**Development Review and Recommendations**  
**Rural Municipality of Victoria**  
**Development Officer Review**

File: V-21-09

Plate 'B' - Details of Proposed Addition – October 15, 2021

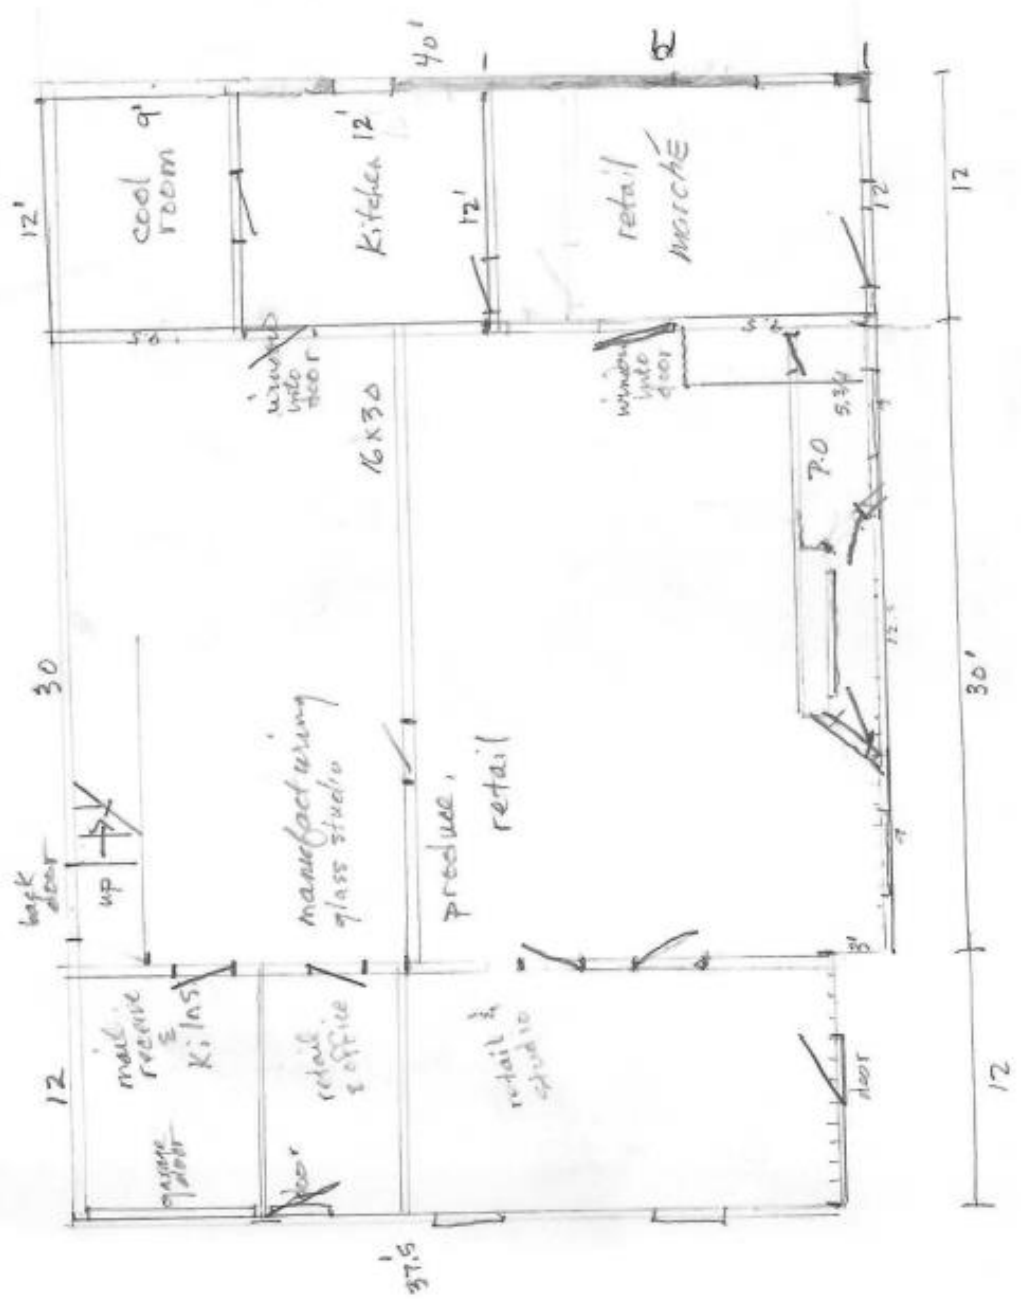
On October 15, 2021 a new application was received with the sketch showing the addition as 12 ft. by 38 ft. on one sketch and 12 ft. by 40 ft. on a plan showing the interior walls and proposed uses. The addition is similar to the one submitted on September 13<sup>th</sup> however the room dimensions are somewhat different. The uses for the kitchen and cooling room did not change. However the takeout is now referred to as retail / marché. In the application the proposed use is stated to be "commercial".

When it was explained that the takeout cannot exceed 200 sq.ft. this notation was deleted from the sketch and is now referred to retail / marché. Retail is a general term and is not listed in the special permitted uses. A restaurant and café is a permitted use. If that is what she wants, then it could be the permitted use.

Appendix C of the Bylaw requires one loading space per 300 sq. ft. for commercial uses. For a restaurant no loading spaces are required. Therefore it is necessary to define exactly what the proposed use will be in the addition. If it is not a restaurant then a loading area would probably be necessary.
